**SECTION 000001 – ADDENDUM NUMBER 2**

**DATE: DECEMBER 8, 2025**

**RE: DCU CENTER ELEVATOR RENOVATION  
50 FOSTER STREET, WORCESTER, MA 01608**

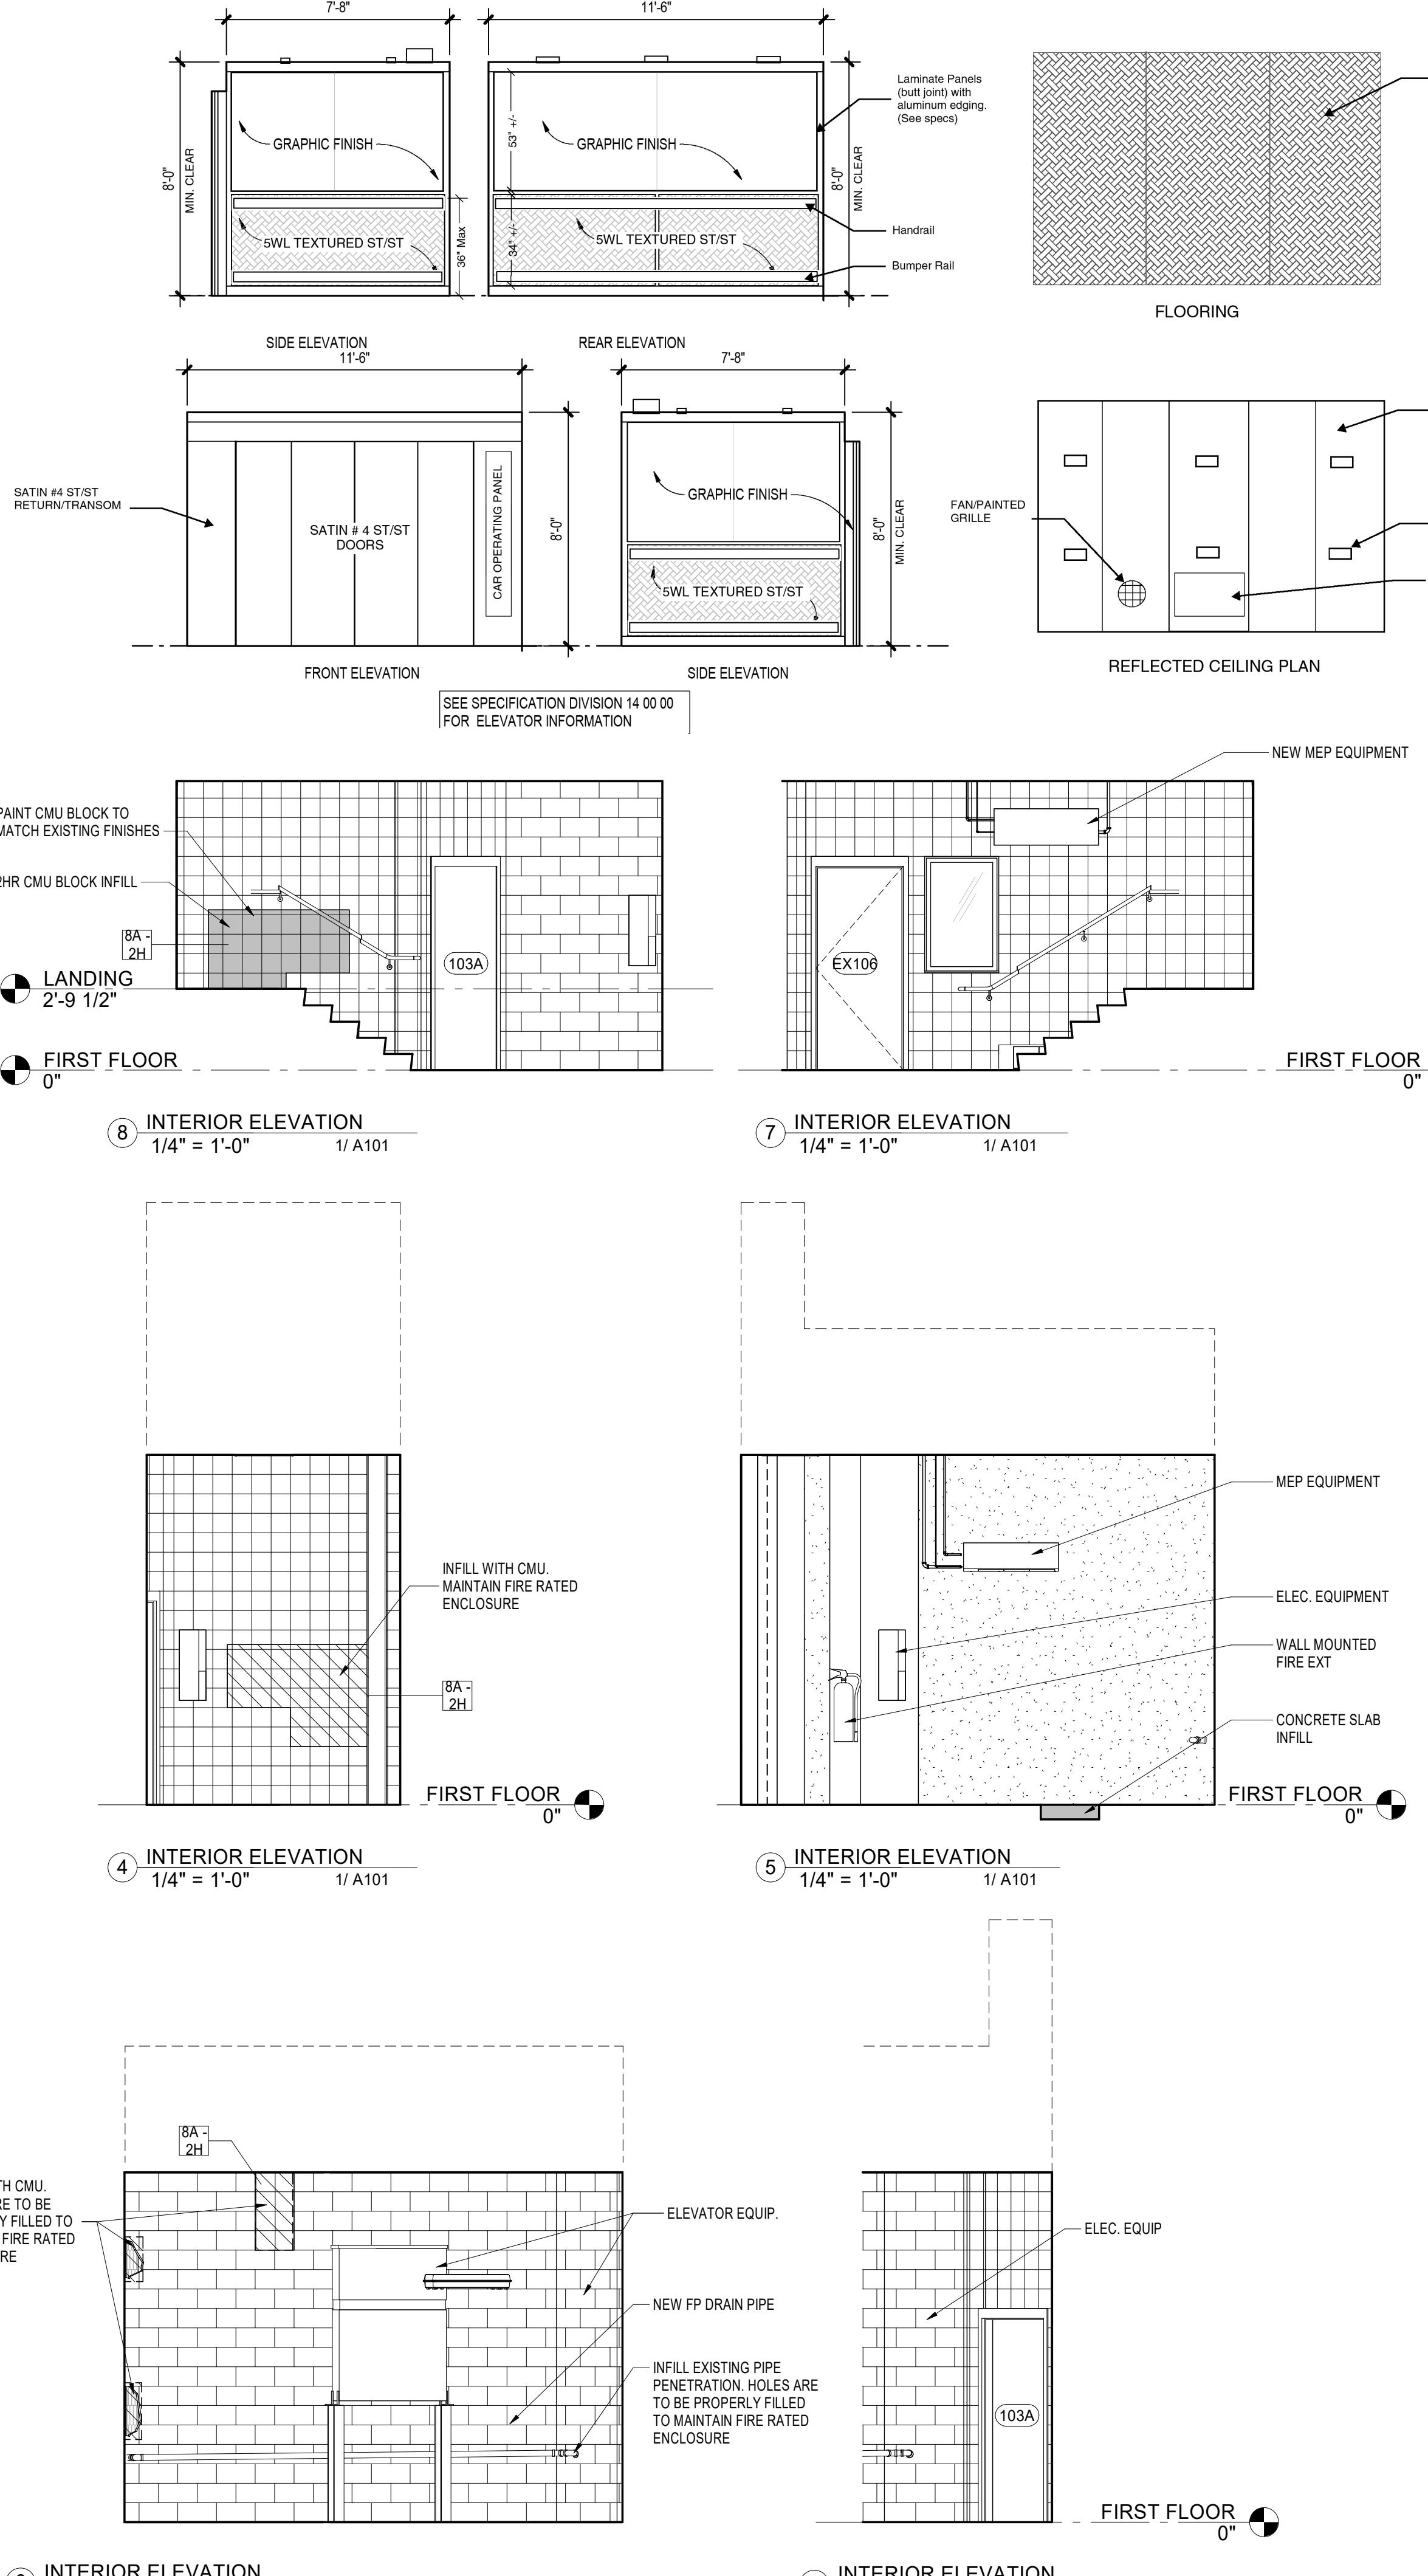
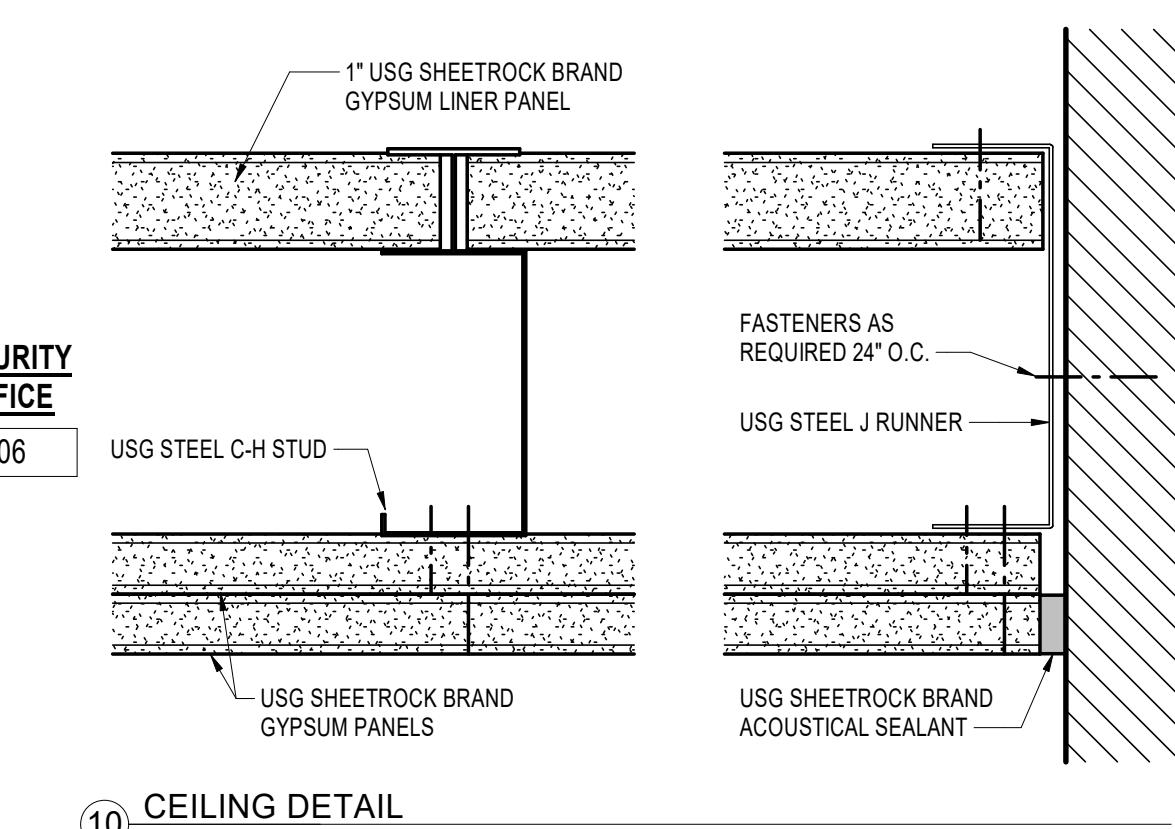
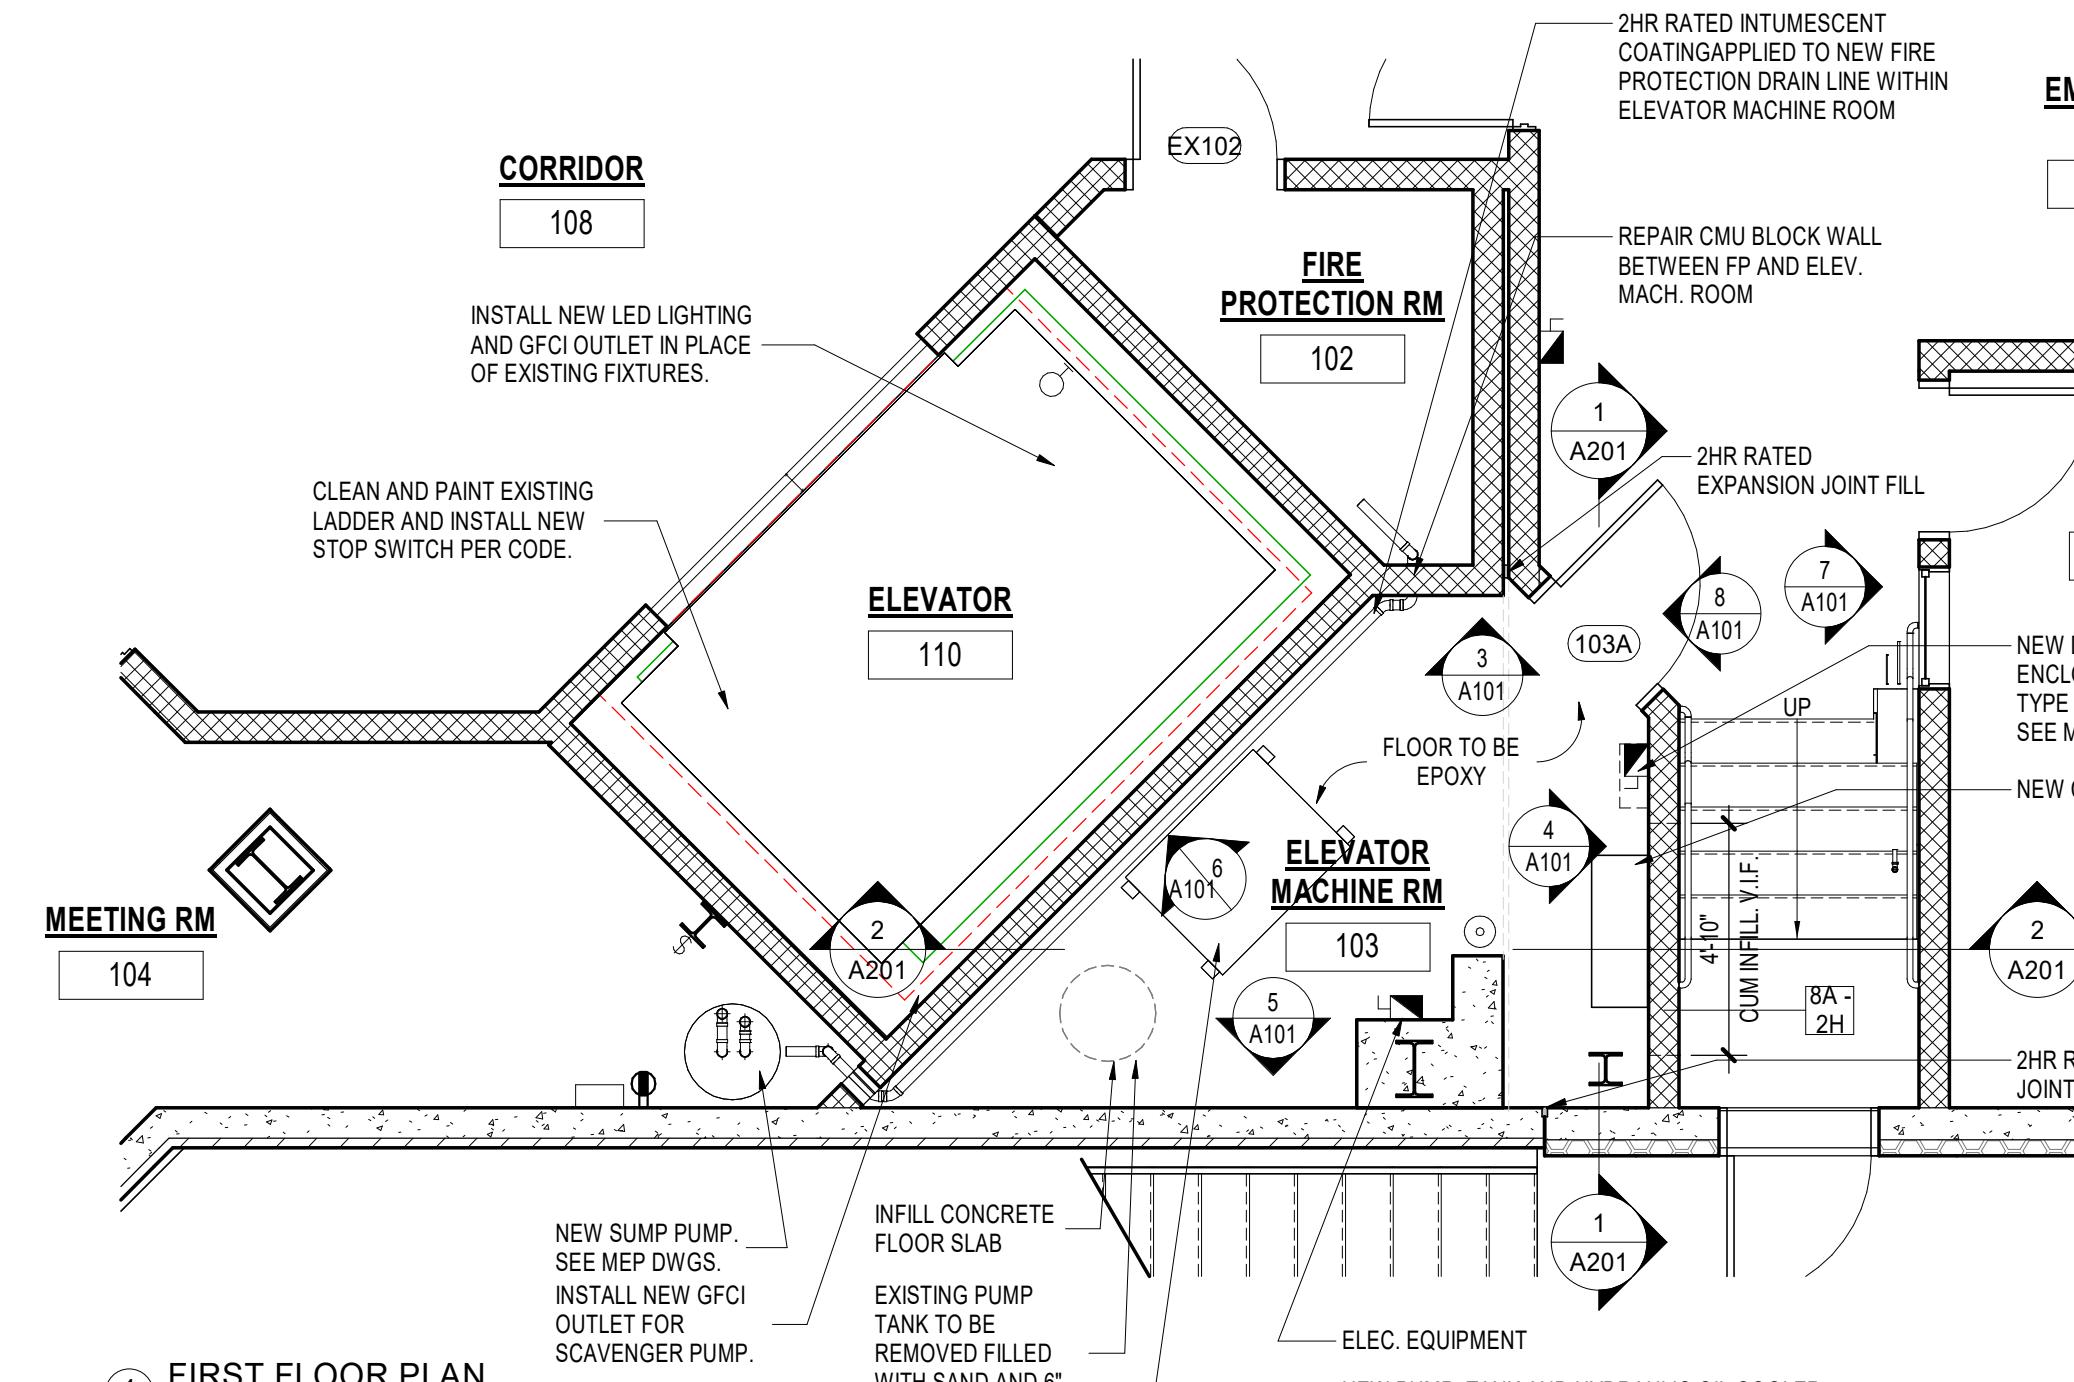
**4.1** **Question:** Details 1 & 2 On A201 shows the route of travel for the new lines for the MEP equipment up to the roof. Please provide scope of work as to how we access the wall cavity space and then close it up.  
**Response:** New lines will be routed through the Storage Room and daylight on the flat EPDM roof and terminated on a pitch pocket. Please refer to attached reissued drawings.
